**BEFORE THE PUBLIC UTILITY COMMISSION
OF OREGON**

LC 67

2017 Integrated Resource Plan

Staff Final Comments

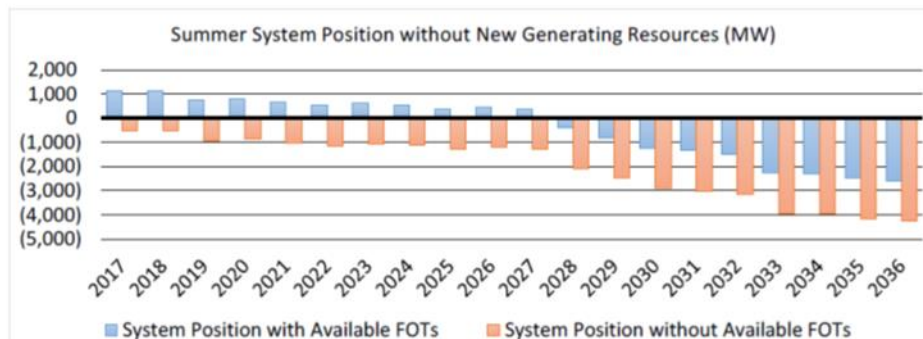
1. PacifiCorp’s justification has not been consistent

PacifiCorp shared the following slide with the Commission and stakeholders:

These claims, however, are not supported by the Company’s filings, workshop statements, or statements in other jurisdictions. Even without new major resource acquisitions, PacifiCorp’s system remains in a state of resource adequacy. Accordingly, the new major resources are by their nature an unnecessary potential economic opportunity that do not need to be acquired to provide reliable service to customers in a least-cost, least-risk manner. PacifiCorp currently has a clear, least-cost, least-risk path to serving customers without the new major resources.

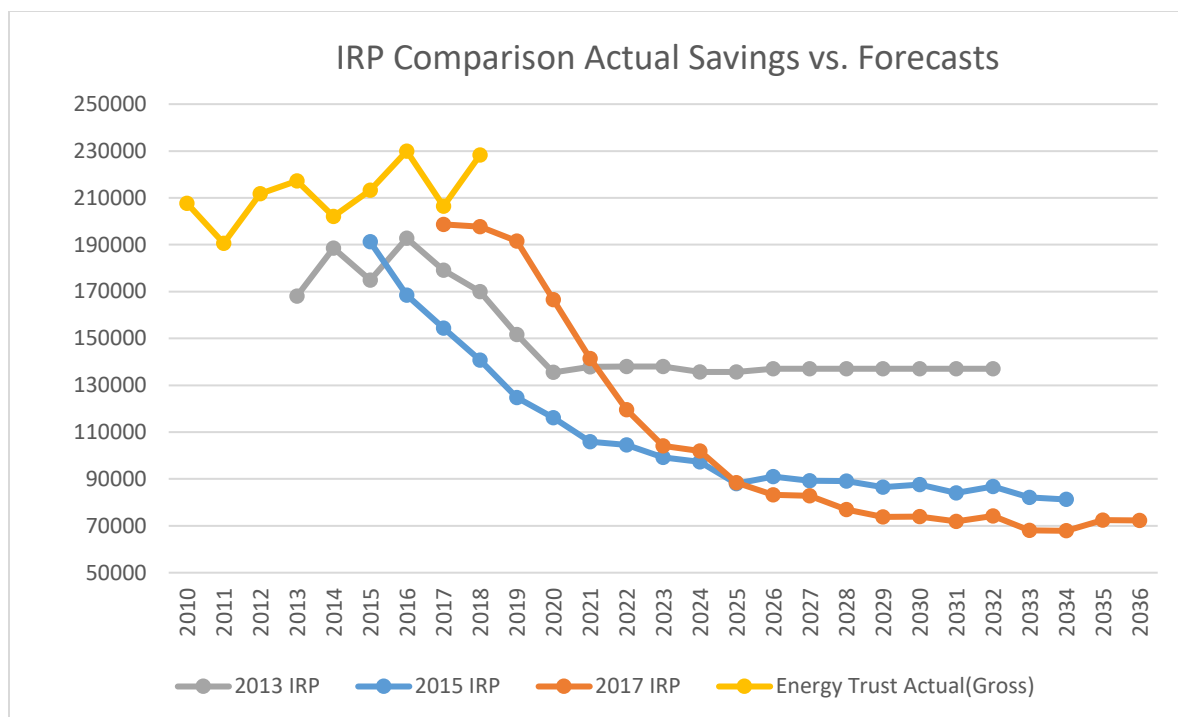
Comparing Energy Trust’s actual, annual EE savings to PacifiCorp’s past three IRP forecasts for EE paints a vivid picture of the consistent under-forecasting taking place.
